### Change in the flange-mount of the turbocharger on the exhaust manifold

**Vehicle Manufacturer:** Peugeot, Citroen, FIAT

**Vehicle:** Boxer 2.2 HDi 110, 130, 150, Jumper/Relay 2.2 HDi 110, 130, 150, Ducato 2.2 Duratorq

**BTS reference:** T916642      **BTS-Service-Set-Nr:** T981460

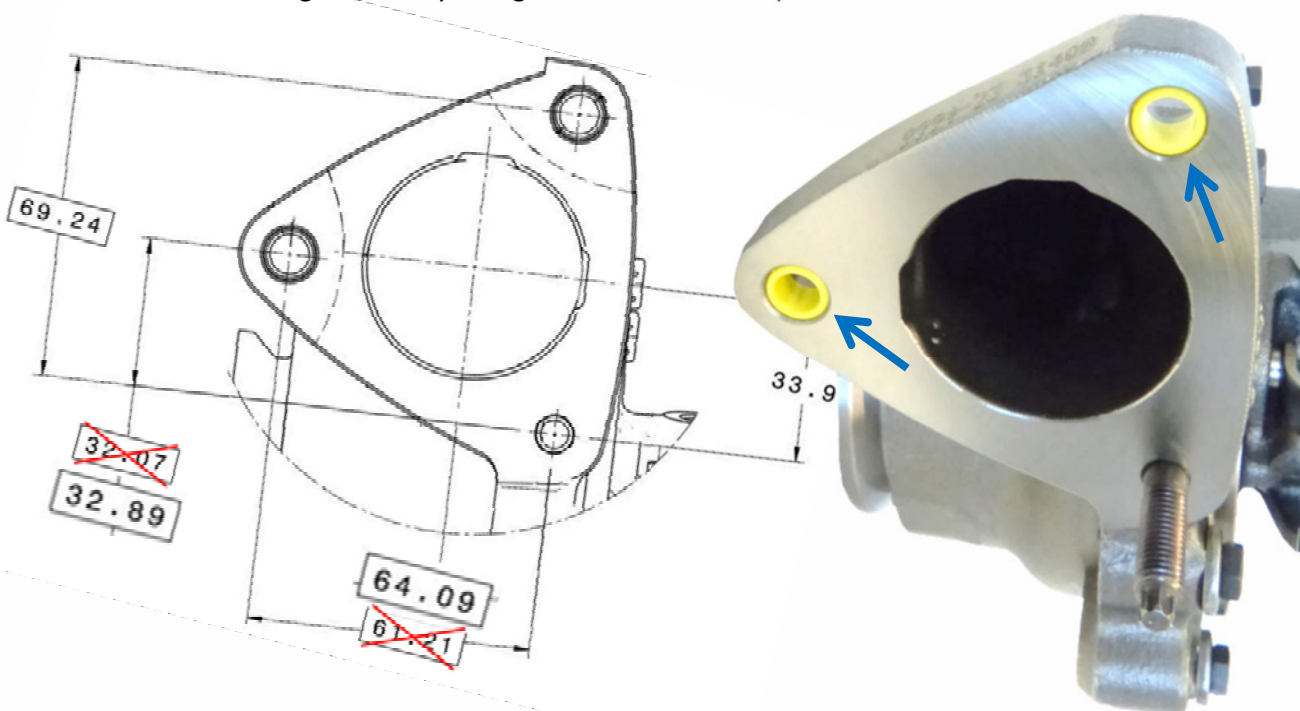
The vehicle manufacturers have introduced a technical modification of the flange-mount of the turbocharger on the exhaust manifold (see modified hole spacing).

If a turbocharger with the reference 798128-0001 (OE: CU3Q6K682AB) or 798128-0002 (OE: 9676934380) was mounted, then when changing the turbocharger, the exhaust manifold has to be exchanged as well (PSA-No. 98 024 513 80).
